VERSION WITH MARKINGS TO SHOW CHANGES MADE

U.S. PATENT APPLICATION SER. NO. 09/737,138
ACCOMPANYING AMENDMENT OF APRIL 27, 2001

In The Specification:

FIG. 9

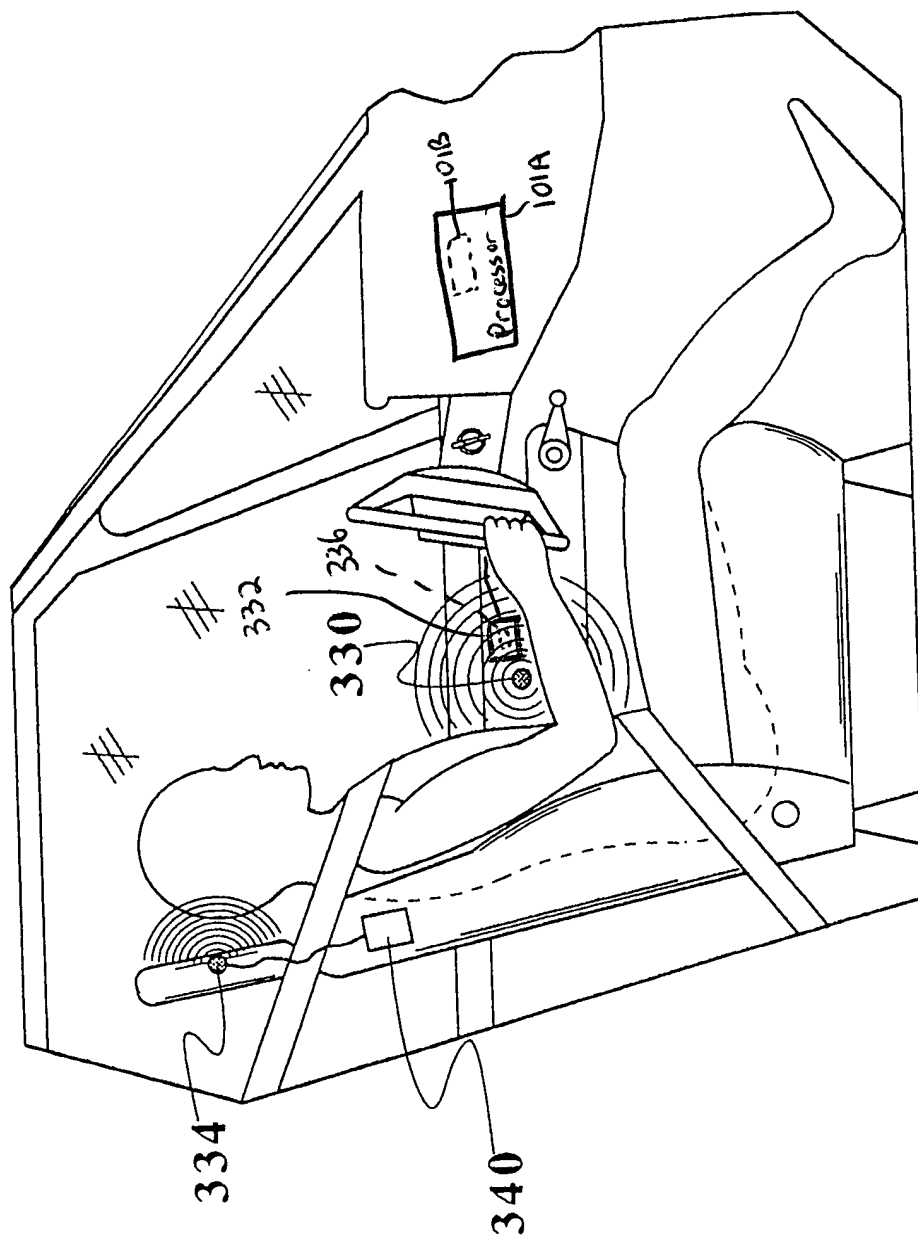
Proposed revised Fig. 9 is submitted herewith in which the side airbag is now shown along with the control circuit resident in the processor. Previously, Fig. 9 referred to the side airbag system which inherently includes an airbag. The corresponding proposed revision to the specification (the paragraph beginning at page 20, line 17) refers to Fig. 4 wherein an airbag control system for a frontal airbag is shown and which is coupled to a processor 101 coupled to the transducers.

system 332 and components of the interior monitoring system, e.g., transducer 330, are coupled to a processor 101A including a control circuit 101B (shown in dotted lines) for controlling deployment of the airbag 336 based on the information obtained by ultrasonic transducer 330. This device is not used to identify the object that is adjacent the airbag but merely to measure the position of the object. It is also understood that it can be used to determine the presence of the object, i.e., the received waves are indicative of the presence or absence of an occupant as well as the position of the occupant or a part thereof. Instead of an ultrasonic transducer, another wave-receiving transducer may be used as described in any of the other embodiments herein, either solely for performing a wave-receiving function or for performing both a wave-receiving function and a wave-transmitting function.

Please enter proposed revised Fig. 9 submitted herewith.

The changes to the specification in connection with the description of proposed revised Fig. 9 do not introduce new matter.

In view of the submission of proposed revised Fig. 9 and the corresponding change to the specification, it is respectfully submitted that the Examiner's objection to the drawings has been overcome and should be removed.
